RPM SUBDIVISION

APPLICATION NUMBER 7 DATE September 18, 2003

REQUEST Subdivision

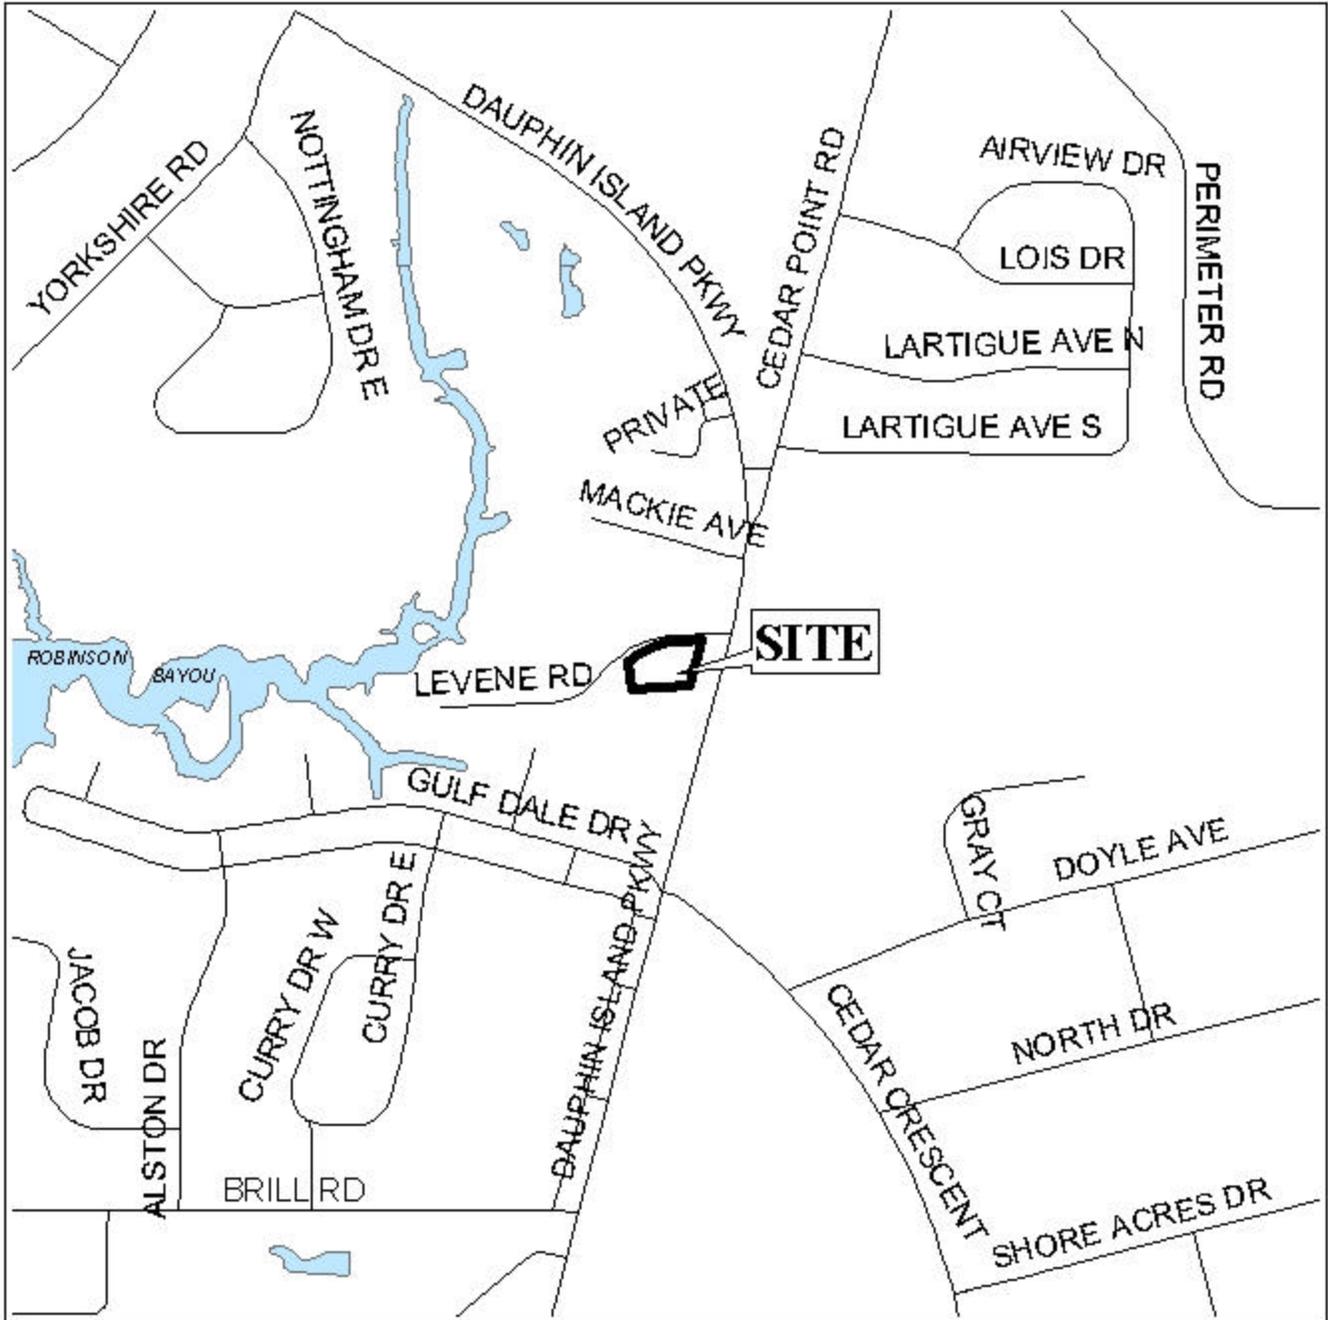
The plat illustrates the proposed 1 lot, 0.7 ± acre subdivision which is located at the Southwest corner of Dauphin Island Parkway and Levene Drive. The subdivision is served by public water and sanitary sewer.

The site fronts Dauphin Island Parkway, a planned major street and the existing right-of-way is not shown; the Major Street Plan requires a 100-foot right-of-way. Therefore, the provision of a dedication from the centerline of Dauphin Island Parkway, to provide for the right-of-way of the planned major street, should be required.

As a means of access management, a note should be placed on the final plat stating that the size, number, location and design of all curb cuts to Dauphin Island Parkway must be approved by Traffic Engineering and ALDOT. As Levene Drive is a residential street and the site is zoned commercial, a note should be placed on the final plat stating that direct access to Levene Drive is denied. With Lot 1 being a corner lot, the dedication of a 25' radius should be required.

The plat meets the minimum requirements of the Subdivision Regulations and is recommended for Tentative Approval subject to the following conditions 1) the dedication of sufficient right-of-way from the centerline of Dauphin Island Parkway; 2) the placement of a note on the final plat stating that the size, number, location and design of all curb cuts to Dauphin Island Parkway must be approved by Traffic Engineering and ALDOT; 3) the placement of a note on the final plat stating that direct access to Levene Drive is denied; and 4) the placement of a note on the final plat stating that with this being a corner lot, the dedication of a 25' radius should be required.
